June 20, 2018

**Subject:** Addendum Geotechnical report in response to 7 LDR- Geology Cycle Issues dated May 29, 2018 for the Subject Property located at 630 Gage Dr, San Diego, CA 92106

**FIGURE B: GEOLOGIC CROSS SECTIONS**  
630 GAGE DRIVE,  
SAN DIEGO, CALIFORNIA 92106

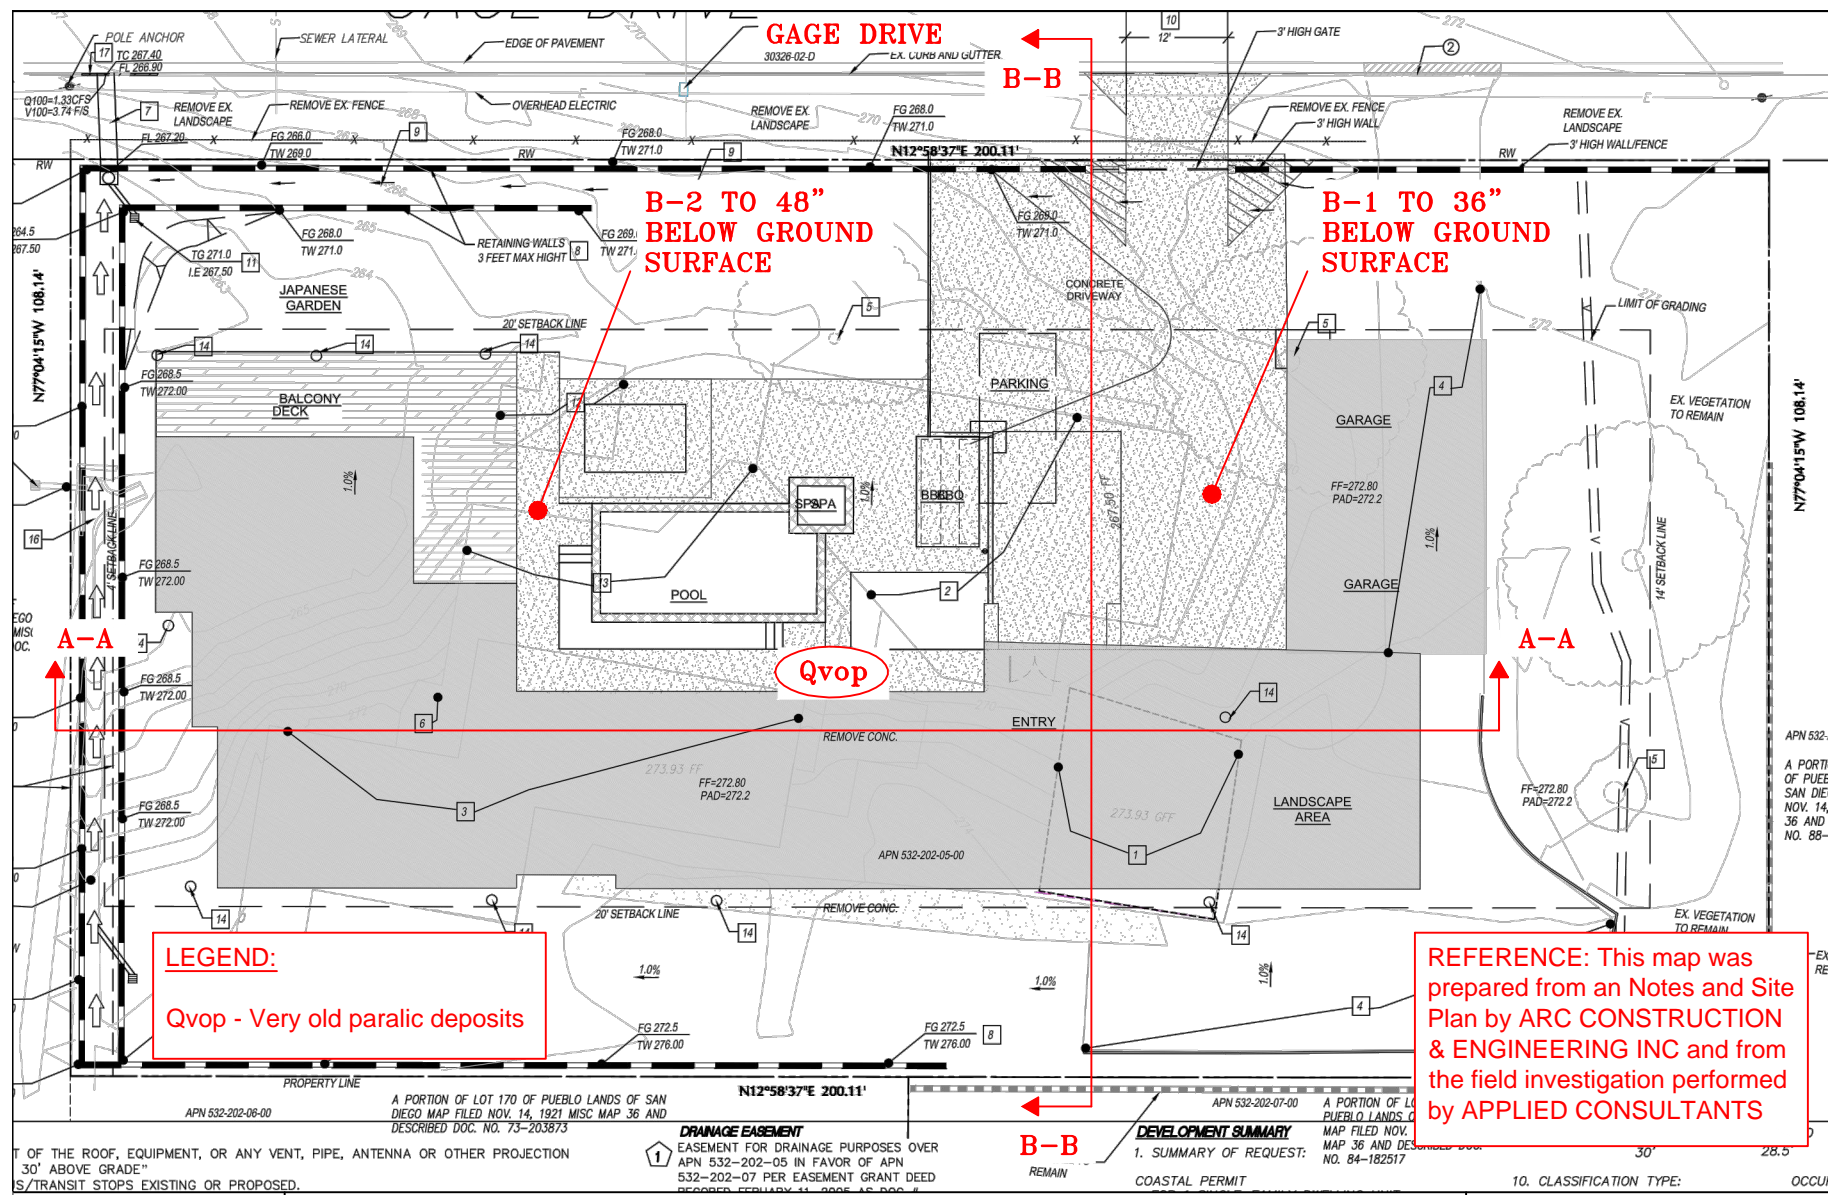
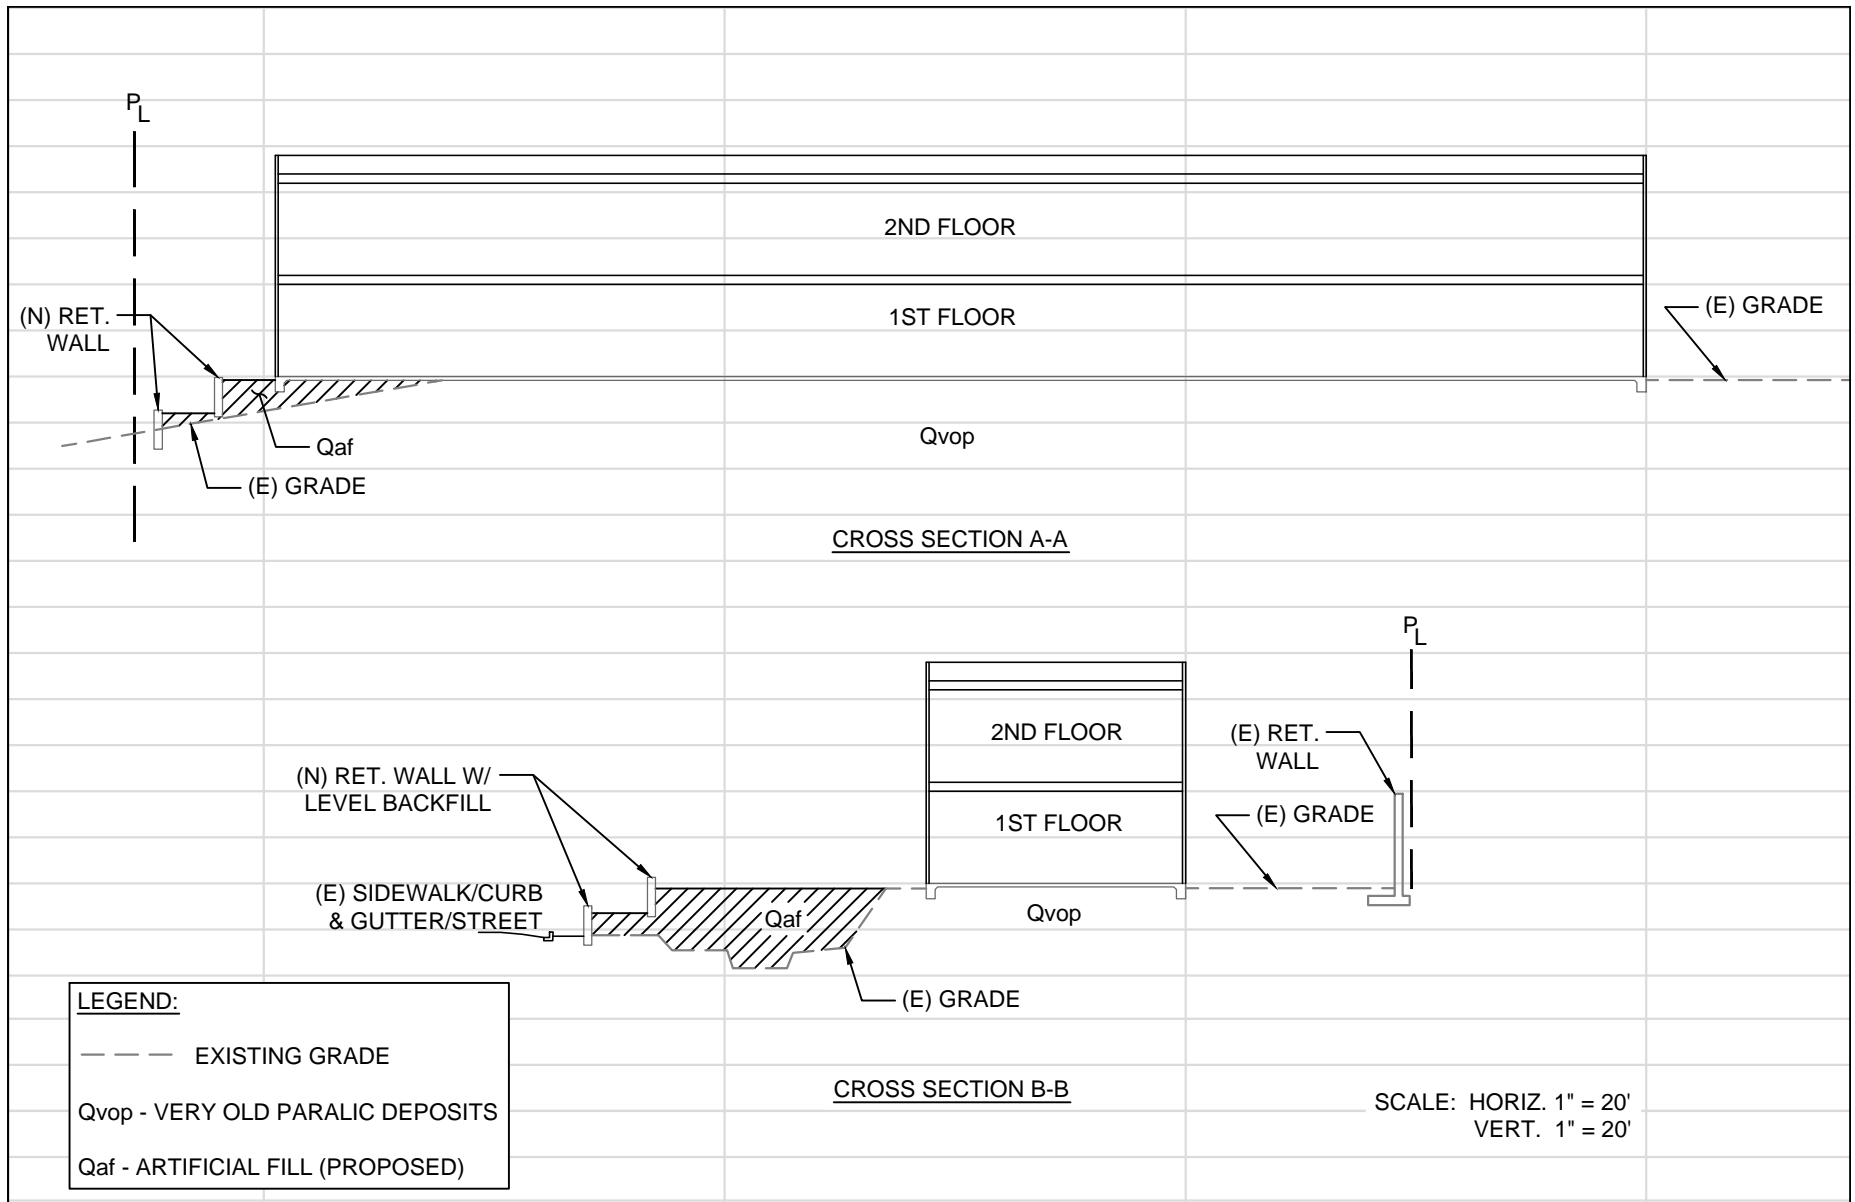
**Issue #17** Show the location of the geologic cross section on the geologic/ geotechnical map. Provide an explanation regarding the mapped geologic units. (New Issue)

**Issue #18** Provide representative geologic cross sections of the proposed construction and the relationship to geologic site conditions. Show the geologic structure on the cross sections. (New Issue)

See Figure A and Figure B of our addendum “Addendum Geotechnical report in response to 7 LDR- Geology Cycle Issues dated May 29, 2018 for the Subject Property located at 630 Gage Dr, San Diego, CA 92106” – The geologic / geotechnical map has been updated and revised so that the location of the geologic cross sections and explanation of mapped geologic units are shown on the map. We have prepared Figure A and Figure B to clarify this issue.

See Figure A and Figure B of our addendum “Addendum Geotechnical report in response to 7 LDR- Geology Cycle Issues dated May 29, 2018 for the Subject Property located at 630 Gage Dr, San Diego, CA 92106” – Geologic cross sections have been prepared so that the proposed construction and relationship to the geologic site conditions is shown. We have prepared Figure A and Figure B to clarify this issue.
